H11509

DESCRIPTIVE REPORT

General Locality Ernest Sound and Eastern Passage

Sublocality Eastern Portion of Bradfield Canal

Figure 2: Junction Between H11508 and H11509

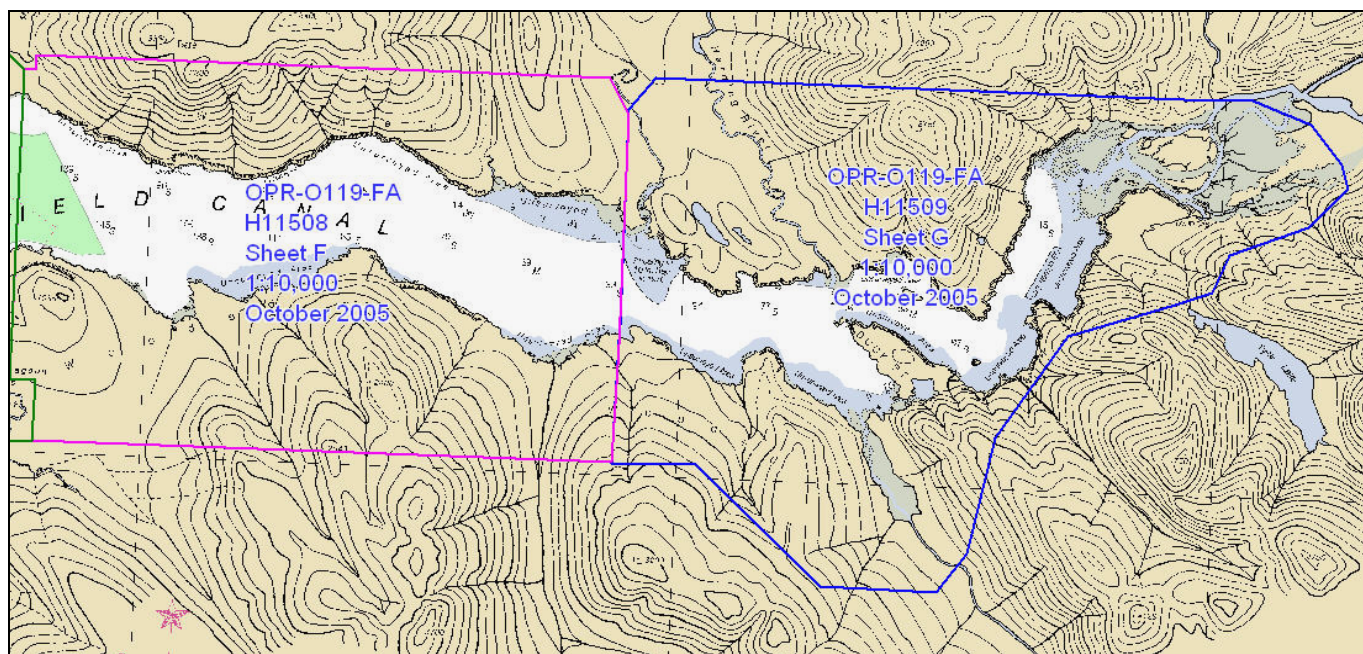
Survey junctions with H11508, which is Sheet F of the same project. The area of overlap between the sheets was approximately 250 meters wide. Data were reviewed in CARIS Subset Editor and depths were found to be consistent between the two surveys, meeting the requirements as stated in the *NOS Hydrographic Surveys Specifications and Deliverables*.⁷ The sheet limits and area of overlap for Sheets G and F are shown in Figure 2.
